4-2 WIRE REPEATERS (J99343RB, RC, RG, RJ)
2-4 WIRE INTERMEDIATE REPEATERS (J99343RD, RE, RH, RK)

INSTALLATION AND TESTING
METALLIC FACILITY TERMINAL

1.001 This addendum supplements Section 332-912-221, Issue 3. Place this pink sheet ahead of Page 1 of the section.

Fig. 13—J99343RJ, RK Precision Balancing Network Switch Functions

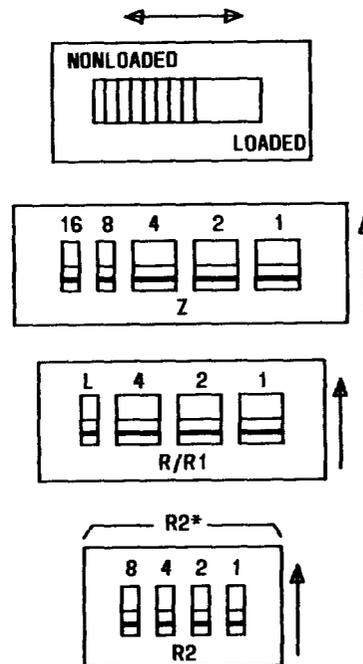
2.003 On Page 10, Fig. 13 is incorrect. A new Fig. 13 is shown in this addendum.
